CRANKSHAFT END PLAY / SPRINT

ORIGINAL FACTORY
SHIMMING METHOD

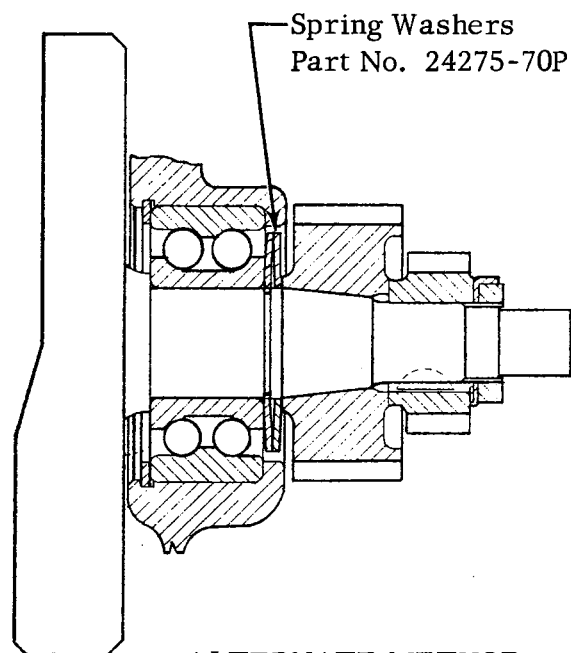
In some cases, the crankshaft endplay on Sprint engines has become excessive and the spacing shims used between the right side crankshaft bearing and shaft lock ring have pounded out possibly causing further damage to the engine.

Note: An engine knock sounding like a piston slap is an indication endplay may be excessive and should be checked. Also check clutch hub nut which also causes knock if loose and use special wrench, part No. 97235-66P to tighten.

Instead of using the original factory shimming procedure to limit the endplay, the following alternate procedure can be used when crankshaft endplay becomes excessive, or when engine base is taken down.

Replace lock ring, 11018P and spacer washers 24272-66P and 24273-62P (if present) using two spring washers, part No. 24275-70P. Assemble spring washers between ball bearing and primary drive gear so that the dished outside diameters contact each other as shown. This will provide zero endplay for crankshaft.
